Delegated Report		Analysis sheet		Expiry Date:		04/07/2022	
		N/A / attached		Consultation Expiry Date:		12/06/2022	
Officer				Application Number(s)			
Sofie Fieldsend				2022/1137/P			
Application Address				Drawing Numbers			
13 Kemplay Road London NW3 1TA				See decision notice			
PO 3/4		Area Team Signature		C&UD		Authorised Officer Signature	
Proposal(s)							
Erection of a replacement two storey dwelling with basement following demolition of existing							
Recommendation:		Refuse planning permission					
Application Type:		Full Planning Permission					
Conditions or Reasons for Refusal:		Refer to Decision Notice					
Informatives:							
Consultations							
Adjoining Occupiers:		No. notified	00	No. of responses	1	No. of objections	1
				No. electronic	00	No. of comments	00
Summary of consultation responses:		<p>Site notices were displayed on the 18/05/2022 and the consultation period expired on the 11/06/2022. A press notice was advertised on 19/05/2022 and expired on 12/06/2022.</p> <p>1 objection was received from a neighbouring property and their objections are summarised as follows:</p>

Erection of a replacement two storey dwelling with basement following demolition

Image 1: 2015 approved scheme shown left and current proposed ground floor shown right.

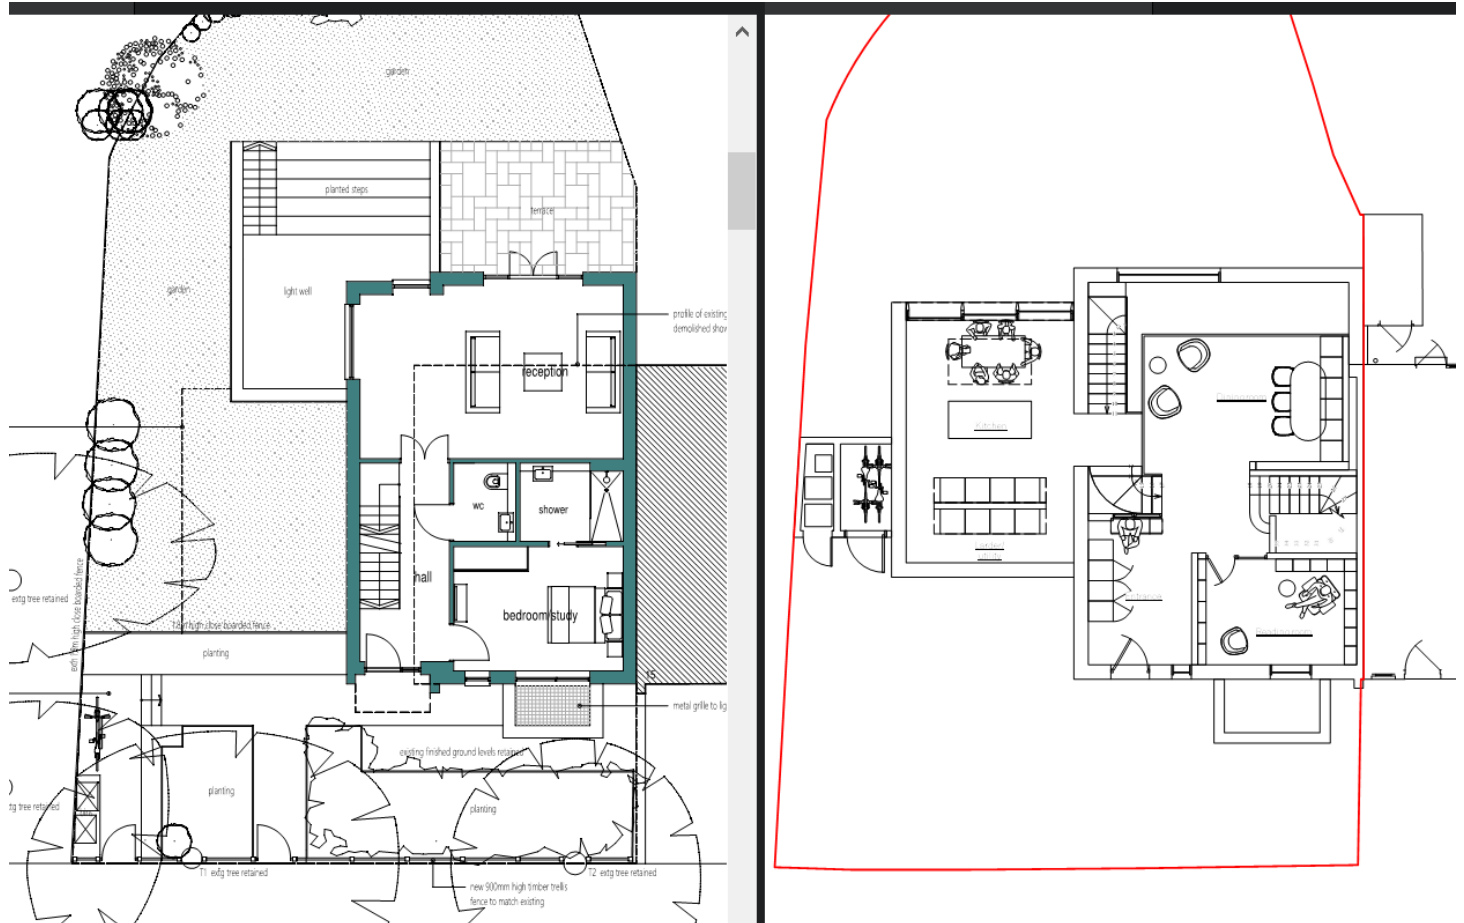
4.9 It should be noted that the comparison outline shown in the design and access statement and consented overlay provided by the agent is incorrect and misleading, no side element was granted in this scheme. The previously approved plans are shown in appendix 1 and the ground floor comparison is shown in image 1 below.

4.14 A ground floor that occupies the full plot width would not be supported in principle, the Council advised the applicant to remove this element during previous pre-app discussions. It more than doubles the width of the existing dwelling and does not appear as a subordinate feature but rather an incongruous and out of character addition to the modest terrace.
